Tech Check and
Correspondence

From: Rose-Coss, Dylan H, EMNRD
Sent: Friday, September 4, 2020 2:09 PM
To: Ramona Hovey
Subject: Re: OWL - The Office SWD

Thanks for putting the seismicity and faulting analysis for the Office SWD No. 1 app together. I do happen to have a few questions though:

| LONQUIST & CO. LLC PETROLEUM ENGINEERS ENERGY ADVISORS AUSTIN • HOUSTON CALGARY • WICHITA BATON ROUGE • DENVER • COLLEGE STATION | OWL SWD Operating, LLC | The Office SWD No. 1 - Proposed | |

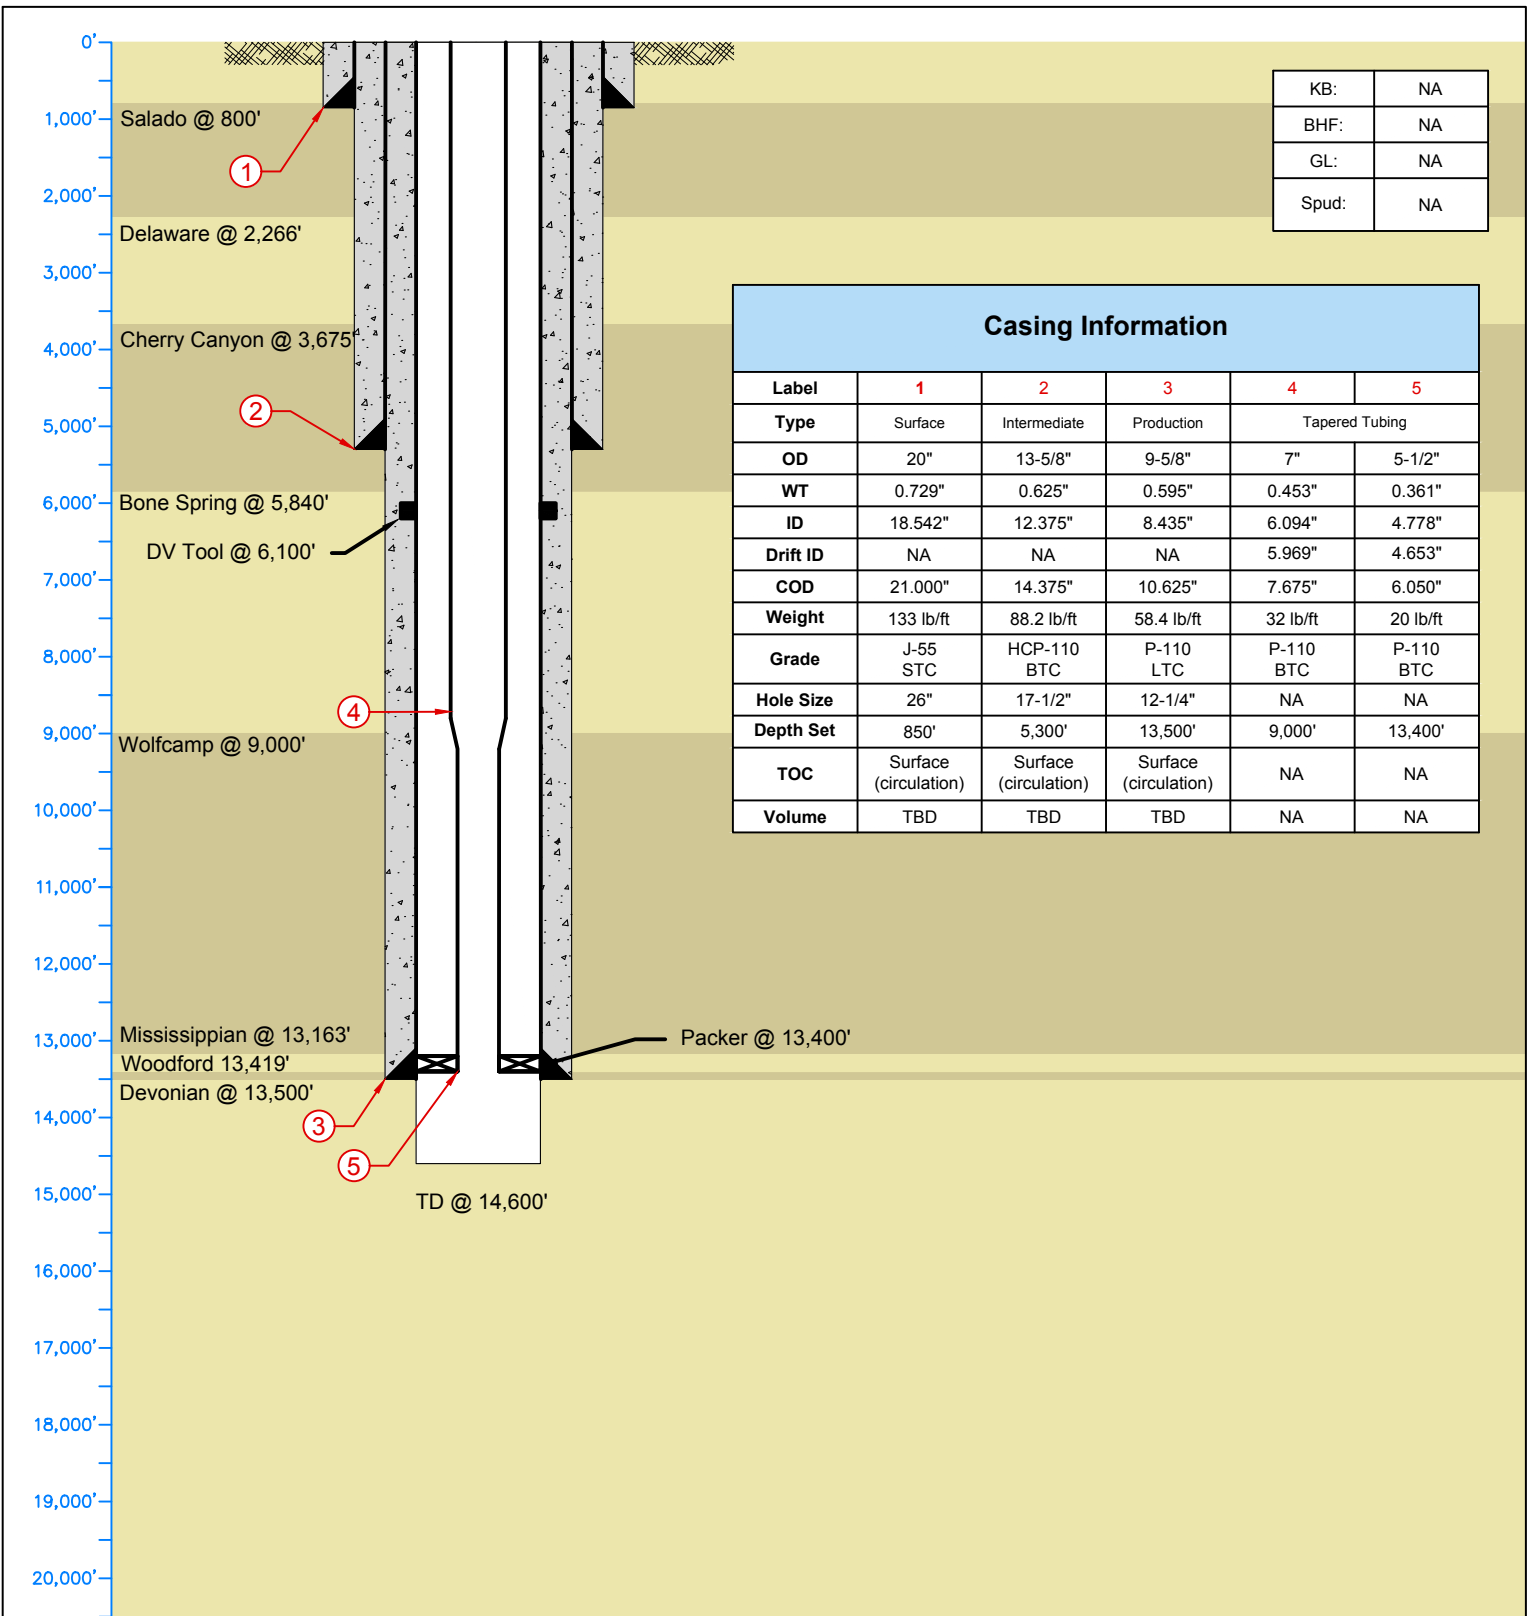
The 7" x 5-1/2" tapered string.

Following up on our call last week regarding The Office SWD tubing design. Would 7" flush joint be acceptable or do we need to go to 7" x 5-1/2" tapered string?

Tubing Size: 7", 32 lb/ft, P-110, BT&C from 0' – 9000' and 5-1/2", 20 lb/ft, P-110, BT&C from 9000'-13400'

Please find our revised schematic and updated C-108 and support document with the tapered design.
